STATE OF MAINE DEPARTMENT OF TRANSPORTATION 16 STATE HOUSE STATION AUGUSTA, MAINE 04333-0016

June 29, 2004 Subject: Wells Pin No. 10169.56 Project No. BR-1016(956) X Bid Amendment No. 2

SPECIAL PROVISION <u>SECTION 510</u> SPECIAL DETOURS

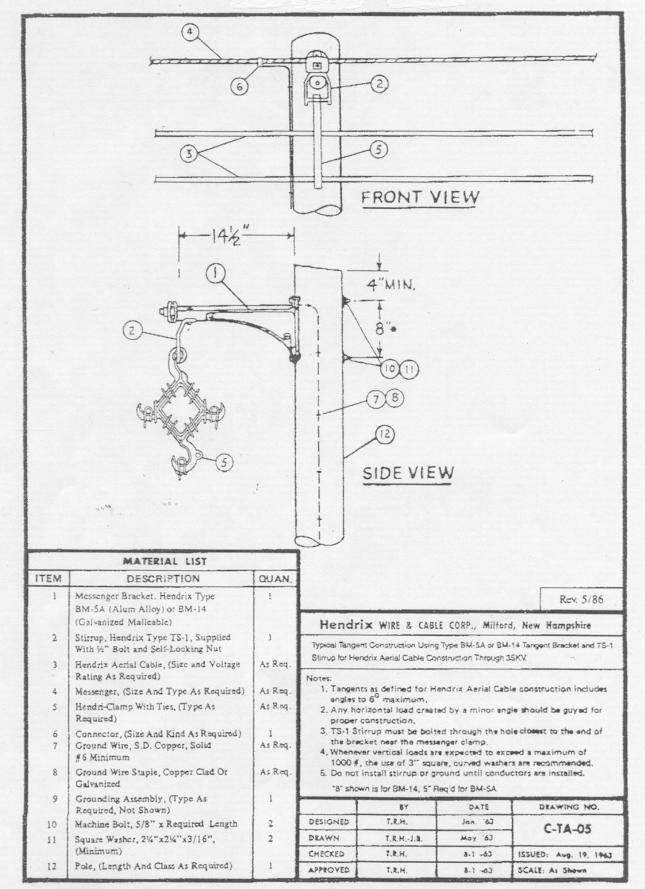
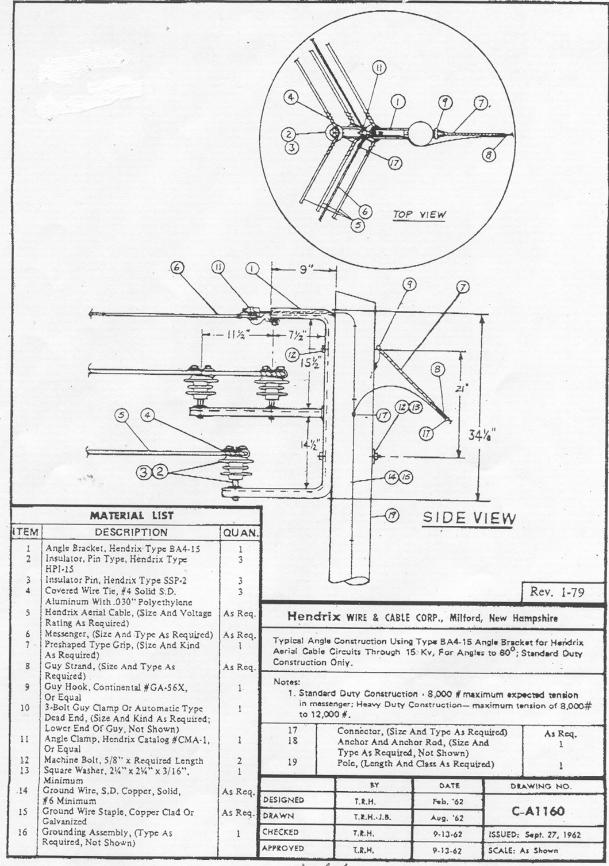
c. Central Maine Power: The temporary utility poles shall be design for and unfactored tension in the sagged cables of 6200 pounds. Holes will be needed to be drilled into the poles to accommodate the attachment scheme shown on a sketch at the end of this Special Provision. CMP shall design, supply and place there own hardware and hangers.
